**CITY OF
PARRAMATTA**

SYDNEY CENTRAL CITY PLANNING PANEL
Addendum Assessment Report

Panel Reference	2018SWC012
DA Number	DA/61/2018
LGA	City of Parramatta Council
Proposed Development	21 storey mixed use building comprising 2 – 3 storey podium containing 5 retail tenancies and 18 storeys of shop-top housing above containing 130 apartments (46 x 1 bed, 70 x 2 bed and 14 x 3 bed) over 4 storeys of basement car parking; public through-site link; and demolition of existing buildings.
Street Address	48-54 Beecroft Road and 52-54 Rawson Street, EPPING NSW 2121 (Lot 2 DP 592094, Lot 1 DP 541808, Lot 1 DP 592094, Lot 2 DP 541808, Lot 4 DP 541960, Lot A DP 325036 and Lot 3 DP 541960)
Applicant	Mr. Sameh Ibrahim
Owner	DGS Epping Development Pty. Ltd.
Date of DA lodgement	25 January 2018
Number of Submissions	48 (42 unique submitters)
Recommendation	Refusal
Regional Development Criteria	The development has a capital investment value of more than \$30 million.
List of all relevant s4.15(1)(a) matters	<ul style="list-style-type: none">Environmental Planning and Assessment (EP&A) Act 1979EP&A Regulation 2000SEPP (Building Sustainability Index: BASIX) (BASIX SEPP) 2004SEPP (Infrastructure) (IS

Figure 1. Revised proposed through-site link. Red line represents split plan between lower ground Rawson Street level (left) and upper ground Beecroft Road level (right).

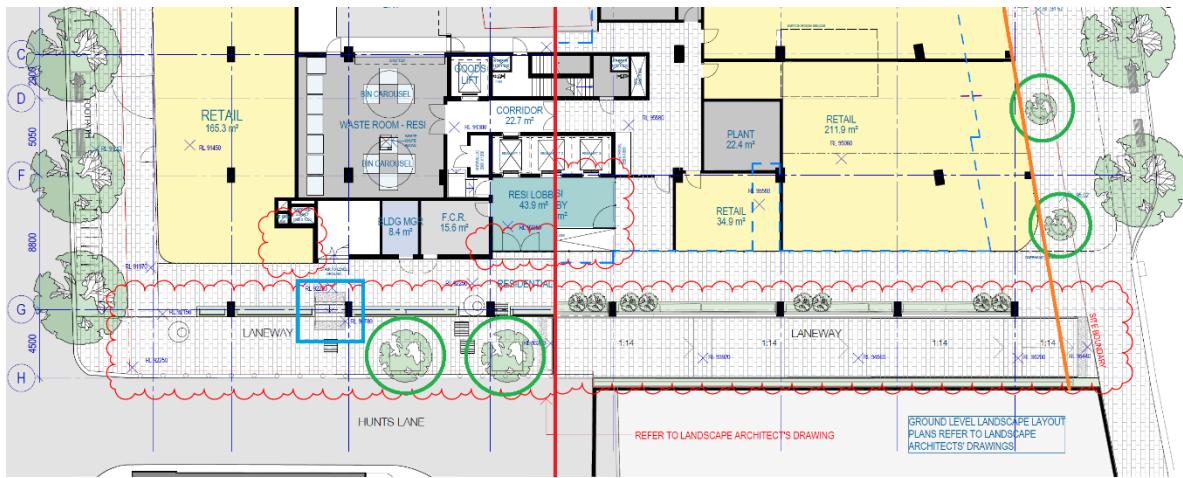
The revised through-site link, though an improvement on the previous design which included stairs, is not considered to be acceptable for the following reasons:

- The Parramatta DCP requires a 1.5m setback to Beecroft Road for the purpose of widening the public footway to accommodate the increased foot traffic projected in the town centre. This setback is depicted by an orange line in Figure 1 above. The top of the pedestrian ramp extends to the boundary and as such would intrude into the 1.5m setback. A 1.5m setback is beneficial in this location and as such the design provision of the DCP should be adhered to in this case.

- The Parramatta DCP requires through-site links to be obstruction free. The proposal includes the following obstructions:
 - The ramp (and Beecroft Road footway) includes trees which block a clear path of travel and are not conducive to optimal pedestrian movement. This issue is depicted with green circles in Figure 1.

- A clear path of travel at the bottom of the pedestrian ramp (i.e. Rawson Street level) is unclear. The proposed stairs connecting the ramp to the retail/lobby level project into possible clear path of travel on the north side of pedestrian lane. This issue is depicted with a blue square in Figure 1.

- How the ramp would integrate with the Beecroft Road pavement, including how the ramp would be divided from the upper ground public domain, and
- Details at the interface of Hunts Lane kerb and the pedestrian lane. It is not clear if this interface is flush and accessible for the full length of Hunts lane.

Figure 2. Extract from revised wind report showing wind tunnel model of proposed development including hedges along Rawson Street, trees in link and baffle screening in link.

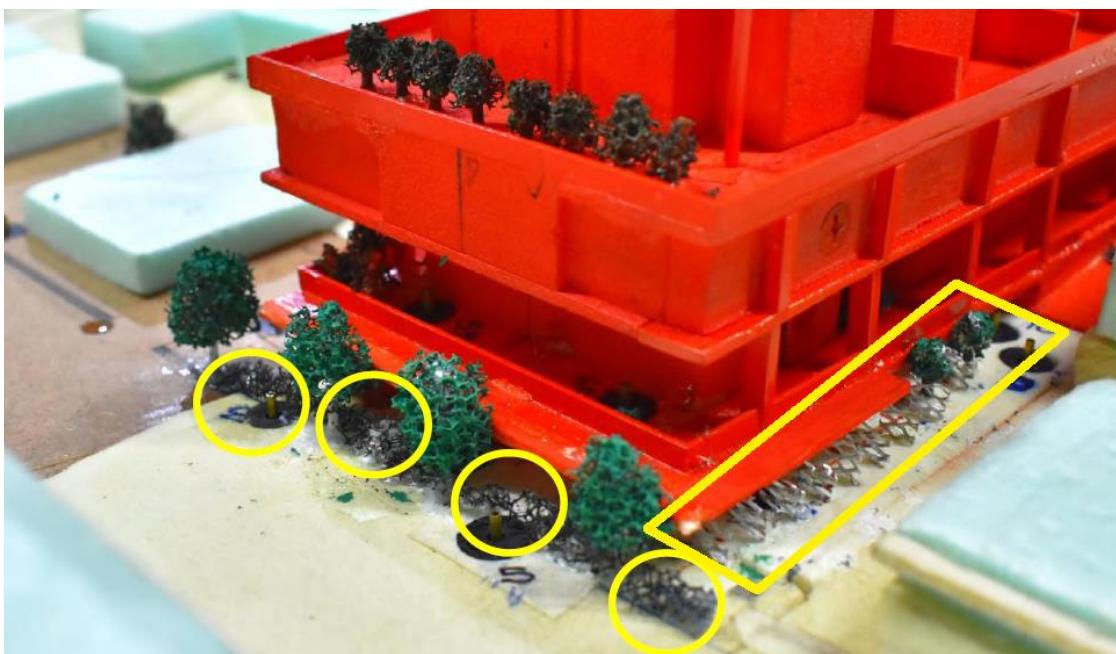
The screening and hedges have not been detailed on the submitted architectural/landscaping drawings. The screening, perpendicular to pedestrian desire lines, along with the trees in the link, would have an unacceptable impact on pedestrian movement. As previously noted, the through site link and Council footways are to be impeded by nothing except the street tree planting anticipated by the Public Domain Guidelines.

While a condition could be included deleting the obstacles, the wind report demonstrates that resulting wind conditions would be uncomfortable at the two ends of the through-site link and along Rawson Street (gusts of up to 21m/s). Given the high foot traffic of these areas, it is considered that comfortable walking should be achieved without impeding pedestrian flows.

As such the proposal does not meet the Parramatta DCP desired future character of Epping Town Centre which seeks to ensure that, "*high rise development must not result in wind tunnelling impacting upon both the public domain and new and existing development*".
